**RESPONSE TO COMMENTS
NEW MEXICO ENVIRONMENT DEPARTMENT (NMED)
THIRD NOTICE OF DEFICIENCY
September 14, 2004**

Comments by the Permits Management Program, Hazardous Waste Bureau, NMED
for
U.S. Department of Energy (DOE) / Sandia National Laboratories (SNL)
August 31, 2004
Response to Comments on July 12, 2004 NMED Notice of Deficiency for
Post-Closure Care Plan (PCCP) for the Corrective Action Management Unit (CAMU)
Technical Area 3

Figure 2-6
Corrective Action
Management Unit
Containment Cell Design Details

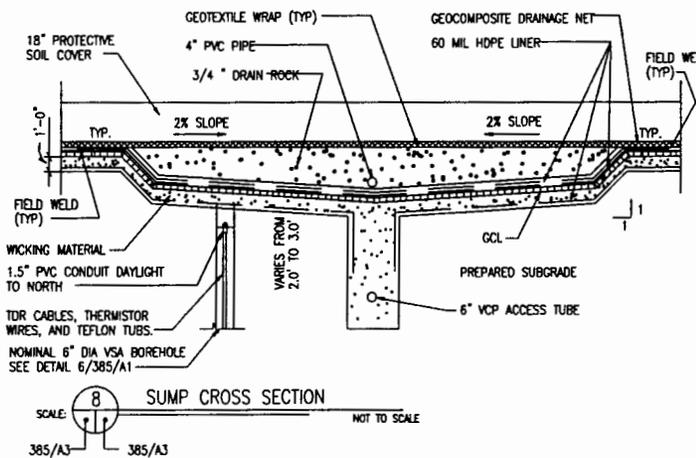
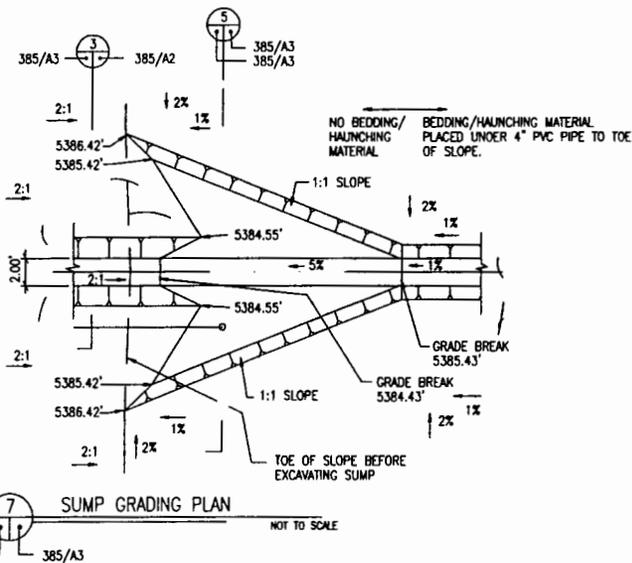
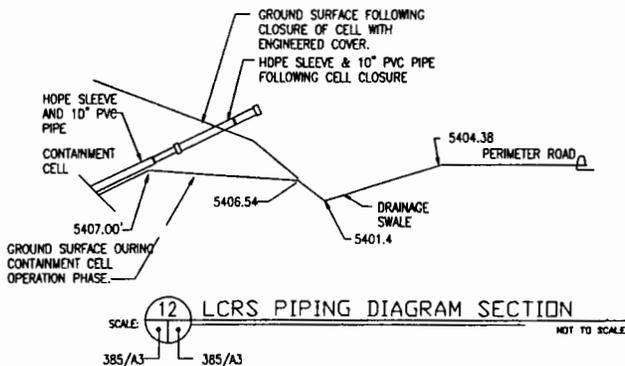
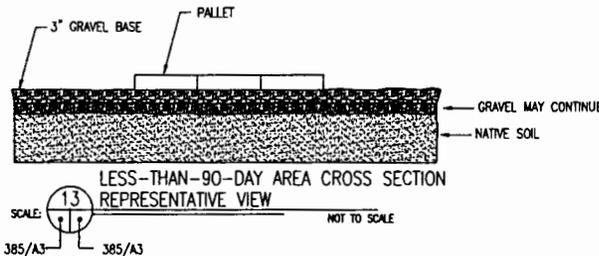
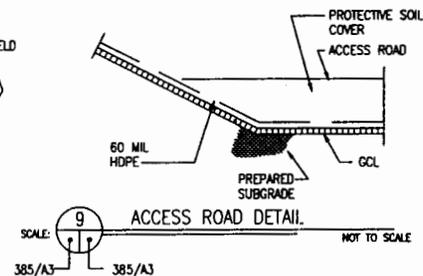
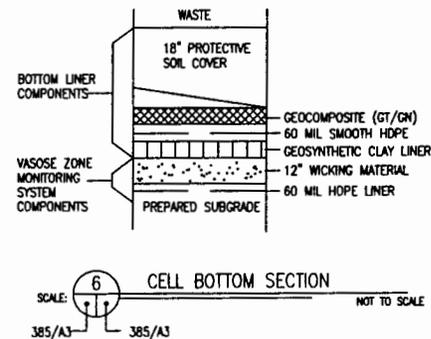
1. Response to Comment #7. This NMED comment required that Figure 2-6, Detail 10, Plan of Leachate Collection and Storage Area, be revised to reflect that the leachate collection tank and appurtenances are no longer in use and that it should be shown as a less-than-90-day drum storage area with the appropriate controls.

In response to this comment, DOE/SNL provided an updated Figure 2-6 to reflect all changes occurring since CAMU closure. These updates included deleting Detail 10, as requested, as well as deleting Details 1 and 3, relating to the now-removed decontamination pad, and Detail 11, relating to the now-removed leachate collection pad.

After deleting these particulars, the remaining detail section numbers were changed to detail sections #1 through #7. In doing so, these detail section numbers no longer match the detail sections that they refer to in Figure 2-4, which is the CAMU Containment Cell Site Plan.

DOE/SNL must correct this discrepancy in detail section numbers. In addition, DOE/SNL must add a detail section of the less-than-90-day area showing a cross-section of the secondary containment pallets on the 3-inch-deep gravel base course.

Response: As requested, we have revised Figure 2-6 to reinstate the original detail numbers and to add a cross-section of the less-than-90-day area. Please see the revised Figure 2-6, Enclosure 2.

REV	DATE	DESCRIPTION	DRN	CHK	APP
△					
△	11/04	LESS-THAN-90-DAY AREA ADDED			
△	11/04	LEACHATE SYSTEM/DECON PAD DELETED
